C6 – HS2 published details 13 August 2015 – REPA edits and questions

Text with REPA queries is highlighted in yellow with some questions in blue

Subject: HIGH SPEED RAIL (LONDON – WEST MIDLANDS) BILL

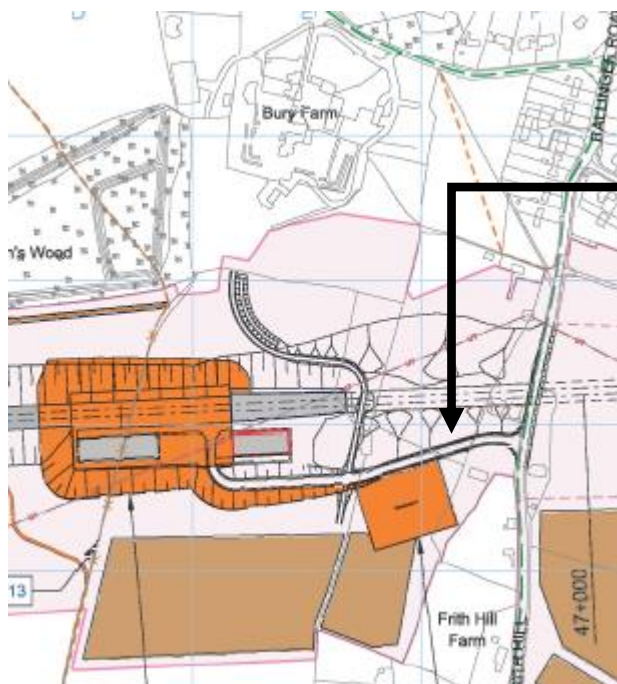
The proposed amendment is for a 2.6km extension of the Chiltern bored tunnel from Mantle's Wood to the current north portal of the South Heath green tunnel (at Ch47+205 excluding the portal hood structure). We presume the portal hood will be 200m long? This would remove the need for the cuttings between South Heath and Mantle's Wood and the South Heath green tunnel currently shown in the Proposed Scheme.

There would be no change to the horizontal alignment of the railway but the vertical alignment would be lower through the tunnel extension than the Proposed Scheme by up to 30m. At the new north portal the tracks would be approximately 17m deep, with the deeper and wider cutting required by the tunnel bore separation and depth gradually reducing to match the Proposed Scheme profile before Leather Lane. (Can we know at what point it rejoins previous profile?) Earthworks around the tunnel portal would integrate with the surrounding landform.

A permanent access road to the northern portal for maintenance and emergency access during operation would be provided from Frith Hill. This would be in broadly the same location as the access road in the Proposed Scheme for the South Heath green tunnel portal. What buildings if any does this lead to demolishing?

Layouts extracted by REPA from CT-05 and 06-033 ie the previous plans for this area showing the road

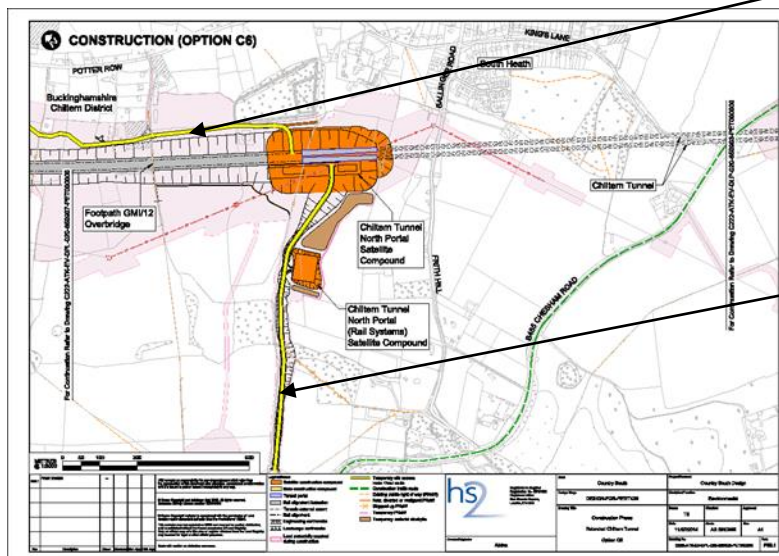
Noise fence barriers within the South Heath cutting and landscape mitigation bunds north of Mulberry Park Farm would continue to be used to improve noise and visual screening in this location. Is there now to be screening for the new permanent access road from the west and also from the Frith Hill SHL as otherwise the portal area will be visible from south heath to south and to west side of portal ?

Does this temporary road that goes next to Jenkins Wood and the trace still exist?

Haul road was permanent and is now temporary
